## STAFF REPORT

Case #18-11: SITE PLAN REVIEW

Case #18-12: SPECIAL PERMIT

91 Cove Street

Looking north from Cove Street into the site at the center of the subject buildings

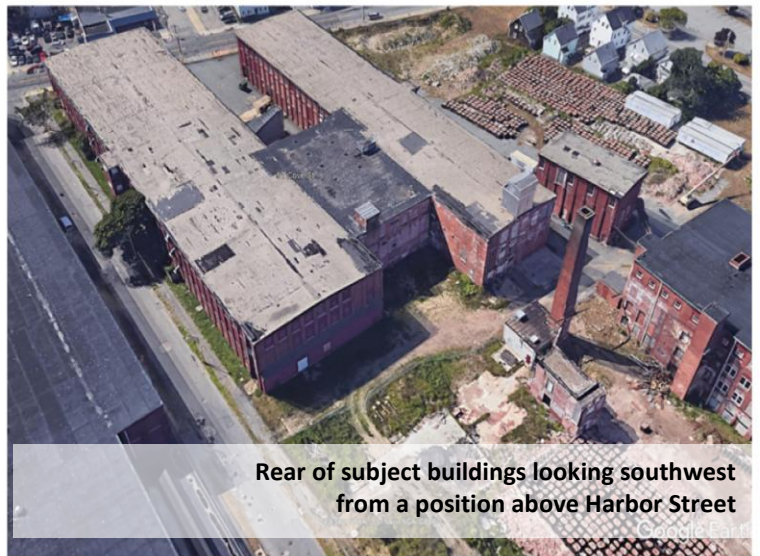
The applicant's existing conditions site plan (Sheet 7 of 10 within the plan set) indicates the presence of 16 diagonally striped off-street parking spaces along the west building's western edge. However, staff's review of the site finds that there are no existing parking spaces existing in this location and in fact, only large weeds and asphalt decay are found where parking is indicated. Access to these particular spaces, were they to exist, would be impossible without reliance on an access easement from the adjoining property to the west. The submitted plans do show such an access easement to the west ("*Access Easement BB Plan 159-88*") that adds roughly 15-20 feet in width to the drive and parking area thus rendering it usable. The easement provides the added benefit of including an existing curbcut along Cove Street. Without this easement this parking cannot be used or counted toward satisfying parking demand, thus it becomes a critical element of the plan. As such, staff recommends a copy of the recorded access easement be included in any final material submission should the project be approved.

- ☐ That the following specific conditions be applied to this decision:
  - A copy of the recorded easement providing curbcut and vehicular access for the 16 “existing” off-street parking spaces should be provided to the City Planner.
